ADDENDUM NO. 1

Menlo Park City School District

Encinal Elementary School

Administration Building Modernization, File No. 41-8 App. No. 01-117917

WINDOW REVISION

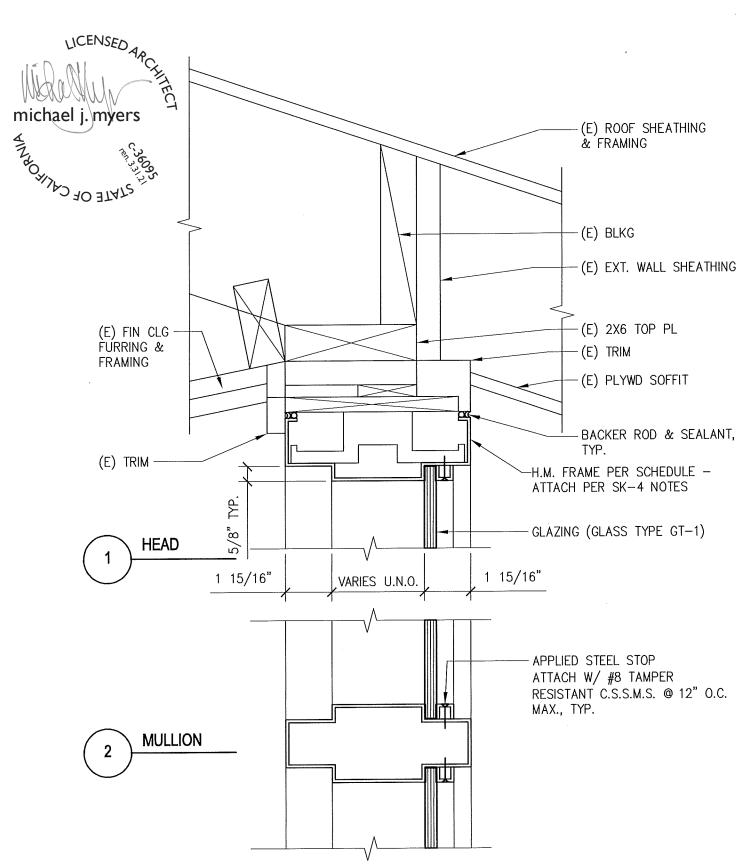
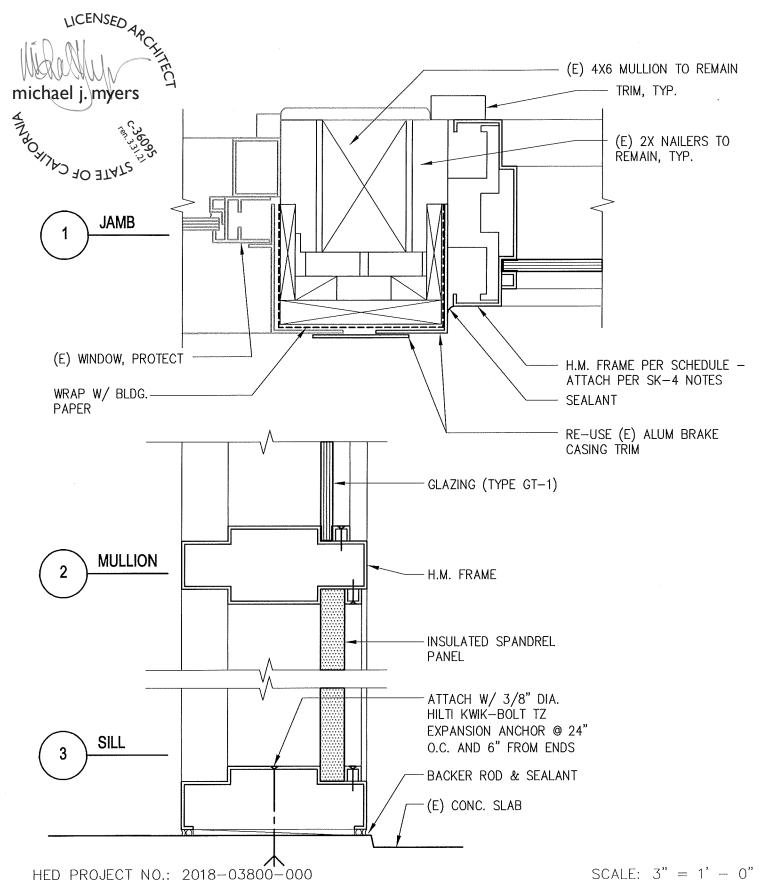
Sheet A101, Window No. "W1"

REPLACE storefront system with hollow metal frame window.

Refer to attached sketches AD-1/SK-1, AD-1/SK-2, AD-1/SK-3 and AD-1/SK-4.
